Access Compliance Report

Public Rights-of-Way

(Curb Ramps)

Intersection ID: 15988	Main Street: SOUTH_BV	Cross Street: HOLLIS_RD	Location: SE
ADA ID: CAB8DF51F8A1	Ramp Type: PerpDiag	Initial Pass/Fail: Fail	Overall Compliance: No
		Severity Score: 10

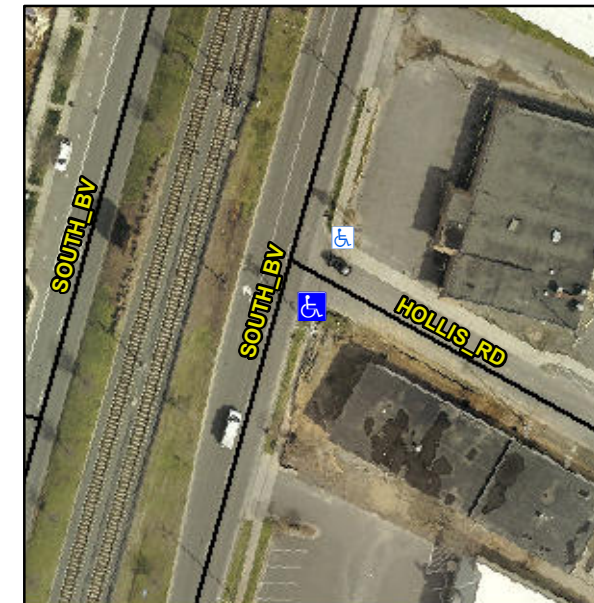
Not Found, R304.5.1, R304.5.3

Compliance	Description	Data	Compliance	Description	Data
N/A	Ramp Length (in)	81.0	Yes	Ramp Slope (%)	5.0
No	Ramp Width (in)	42.0	No	Ramp XSlope (%)	4.2
N/A	Flare Type LT	N/A	N/A	Flare Type RT	N/A
N/A	Flare Slope LT (%)	N/A	N/A	Flare Slope RT (%)	N/A
N/A	Flare Traversable LT?	N/A	N/A	Flare Traversable RT?	N/A
N/A	Landing Length (in)	N/A	N/A	DWS Provided?	N/A
N/A	Landing Width (in)	N/A	N/A	DWS Contrast?	N/A
N/A	Landing Slope (%)	N/A	N/A	DWS Length (in)	N/A
N/A	Landing X Slope (%)	N/A	N/A	DWS Full Width?	N/A
N/A	Landing Curb? (Y/N)	N/A	N/A	DWS Offset (in)	N/A
N/A	Shared Landing?	N/A			
N/A	Gutter Ponding?	N/A	N/A	Gutter Slope (%)	N/A
N/A	Gutter Lip Ht (in)	N/A	N/A	Gutter X Slope (%)	N/A
N/A	Painted X Walk1?	No	N/A	Painted X Walk2?	No
	X Walk 1 Direction	To NE		X Walk 2 Direction	To NW
N/A	X Walk 1 Width (in)	N/A	N/A	X Walk 2 Width (in)	N/A
	X Walk 1 Slope (%)	1.9		X Walk 2 Slope (%)	2.0
	X Walk 1 X Slope (%)	0.3		X Walk 2 X Slope (%)	6.6

Remove & Replace Curb Ramp With Two New Directional Ramps or Equivalent.
